PanoVu Mini Series PTZ Camera V5.4.10

Release Note

Firmware Basic Information	Firmware Version:	V5.4.10 build 180122
	SDK Version:	V5.3.2.5_build20171026
	Play Library (PlayCtrl.dll)	V7.3.3.64_Build20170815
	Encapsulation Library (SystemTransform.dll)	V2.5.1.9
	Voice intercom library	1.3.0.5
	iVMS-4200	V2.6.5.4Build20171114
	IE Client version	V4.0.1 build 171117

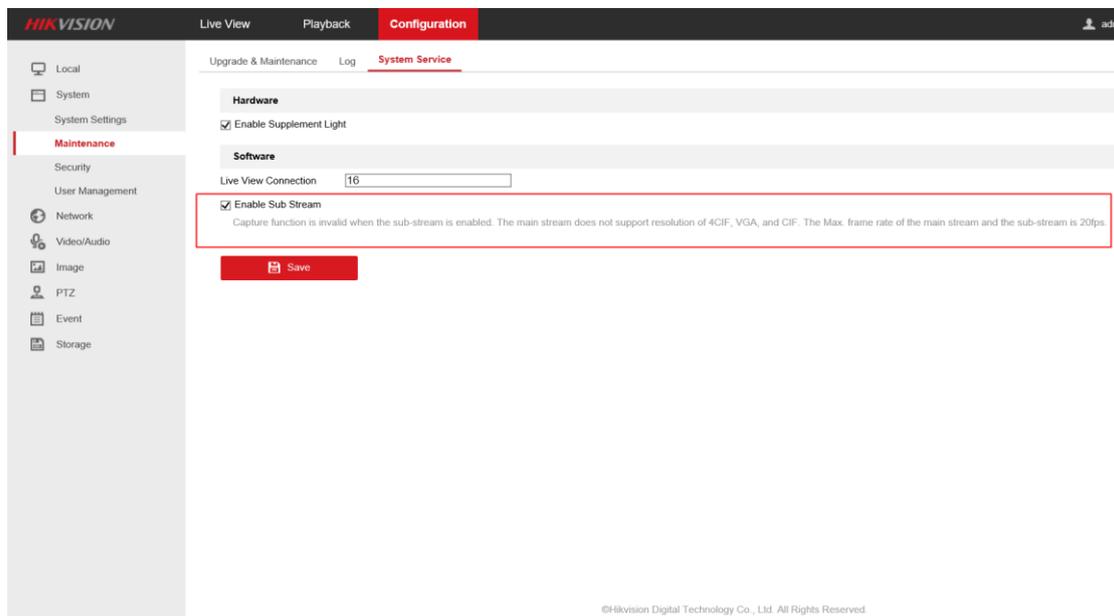
- 1) Live View interface, Video/audio interface, Image interface, Record interface and Playback interface all support four channels.**

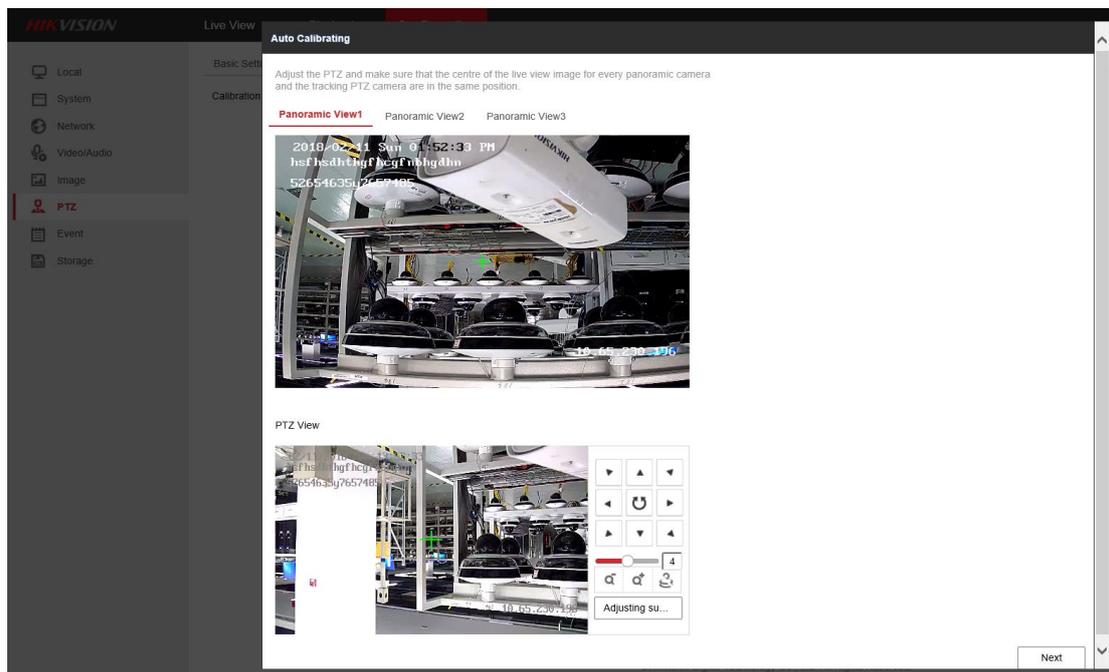
3) Panorama Linkage function of DS-2PT5326IZ-DE supports auto calibration and the panorama lens position can be adjusted; DS-2PT3326IZ-DE3 and DS-2PT3122IZ-DE3 not support Panorama

Linkage function.
